System Impact Assessment Report (Addendum)

East Windsor Cogeneration Centre

CAA ID 2006-234

Document ID	IESO_REP_0401
Document Name	System Impact Assessment Report (Addendum)
Issue	Issue 1.0
Reason for Issue	Change of Configuration
Effective Date	April 15, 2008

Figure 3: Proposed Modified 115 kV Configuration (Normal Conditions)

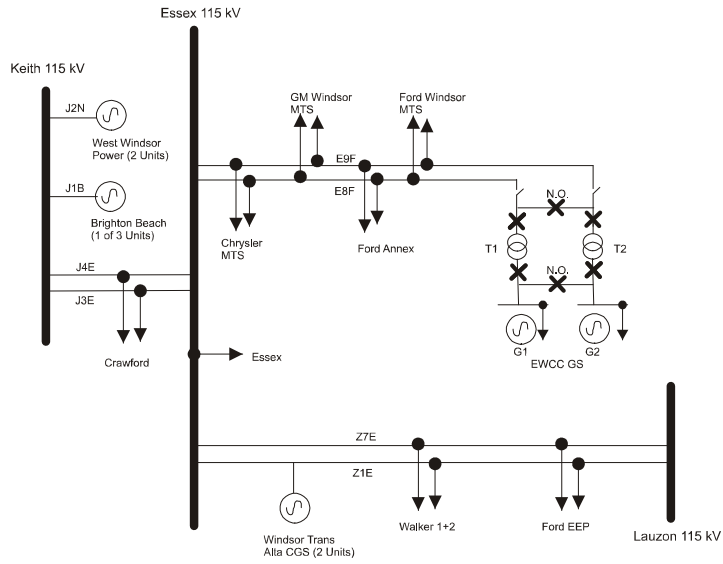
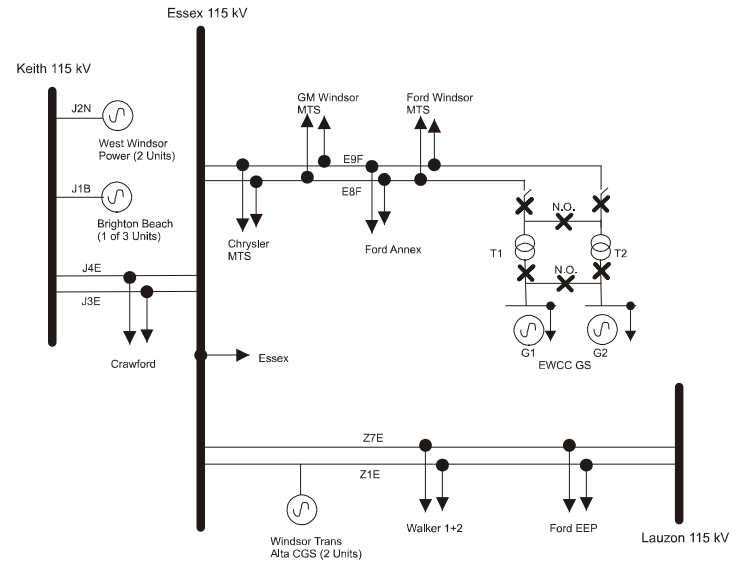
Based on recommendation from Hydro One, EWCC is proposing to relocate the 115 kV bus tie breaker. **Figures 2 and 3** show the original and proposed modified 115 kV EWCC configuration respectively under normal operating conditions. Under normal operating conditions both the 115 kV and 13.8 kV tie breakers are kept open such that one generator is connected to E9F and the other is connected to E8F. A comparison shows that these two configurations appear electrically identical. As such, all contingencies that were observed under normal conditions in the original SIA are not impacted by the modification.

The proposed relocation of the 115 kV bus tie breaker does not have a negative adverse impact to the reliability of the IESO-controlled grid.

Figure 5: Proposed Modified 115 kV Configuration (E8F Outage Conditions)

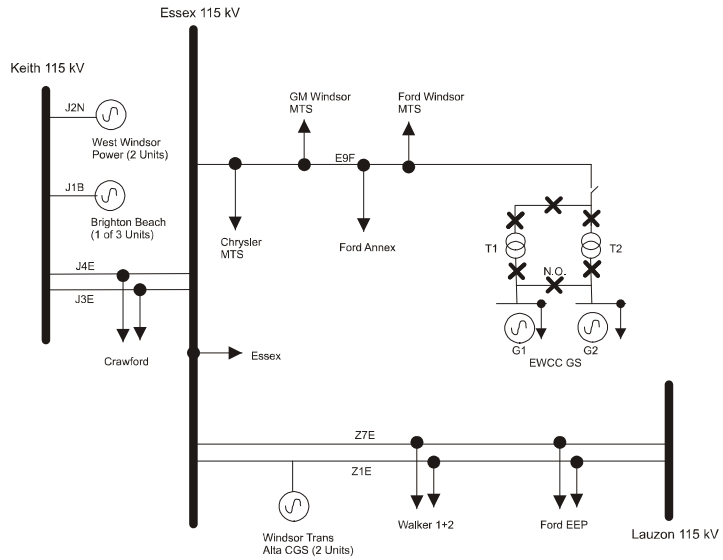
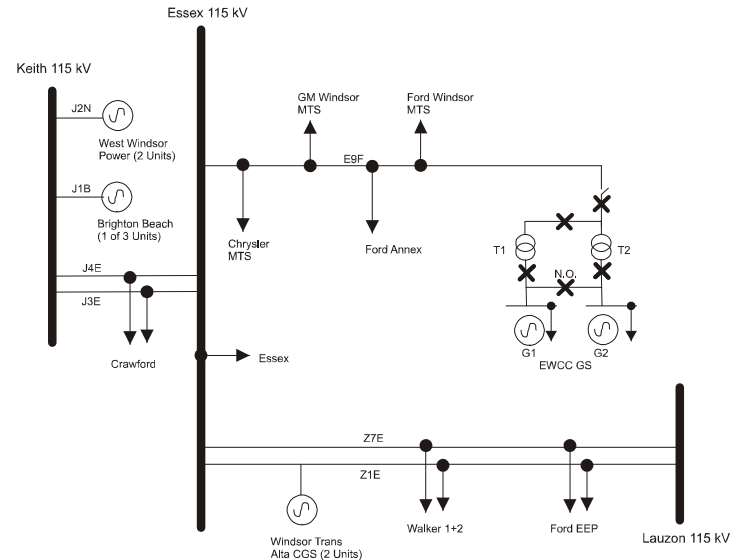
During an outage to E8F/E9F, the closing of the bus tie breaker allows for the connection of both EWCC G1 and G2 to the remaining E8F/E9F line. **Figures 4 and 5** show the original and proposed modified 115 kV EWCC configuration, respectively, under an outage to E8F. With the relocation of the 115 kV bus tie for E8F or E9F outage conditions, the out-of-service line will be isolated by the motor disconnect switch and the EWCC T1/T2 115 kV breaker.

The following table lists the EWCC breakers that would open under pre and post bus tie relocation configurations for various contingencies during an E8F outage. Although, each configuration differs in terms of which breakers open, the final state of the system still remains the same regardless of the configuration. Therefore, all contingencies that were observed under the E9F/E9F outage condition in the original SIA should not be impacted by the modification.

FIGURE 6: MODIFIED ESSEX TS LAYOUT

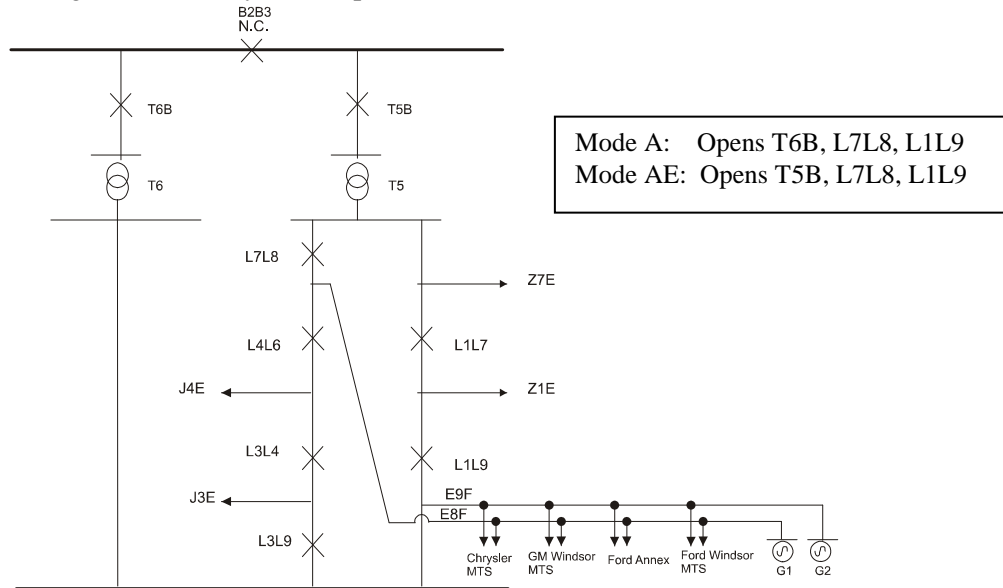
Essex 115 kV TS station has recently been reconfigured. The Z7E and E8F terminations at Essex TS have been interchanged to provide more flexibility in splitting the Essex 115 kV busbar (Mode A and Mode AE splits) for Winsor Area Overload Protection scheme related contingencies. The post-interchange Essex TS station diagram is shown in **Figure 6**. This reconfigured configuration was accounted for in the original EWCC System Impact Assessment.

Since the release of the original SIA, modifications have been made to the Windsor Area Overload Protection Scheme to reflect the station reconfiguration. Changes have been made to the operation of Mode A and Mode AE splits for the loss of J3E or J4E. The changes are as follows:

- (1) **For a J3E circuit fault:** If a Mode A or Mode AE split is initiated as a result of a J3E fault, a transfer trip signal is to be sent to the MTS transformers connected to E9F.
- (2) **For a J4E circuit fault:** If a Mode A or Mode AE split is initiated as a result of a J4E fault, a transfer trip signal is to be sent to the MTS transformers connected E8F.

With the incorporation of EWCC, transfer trip signals would also need to be sent to the corresponding EWCC generator on E8F or E9F under a Mode A or Mode AE split for the loss of J3E or J4E. This would prevent any EWCC generation islanding with its station load. The *new* Mode A and Mode AE split operations requirements for the loss of J3E or J4E are summarized in the table below:

New Mode A and Mode AE Split Operating Requirements for Loss of J3E or J4E	
Contingency	Transfer Trip Signal
J3E	<ul style="list-style-type: none"> • Signal sent to MTS transformers connected to E9F • Signal sent to EWCC generation connected to E9F
J4E	<ul style="list-style-type: none"> • Signal sent to MTS transformers connected to E8F • Signal sent to EWCC generation connected to E8F
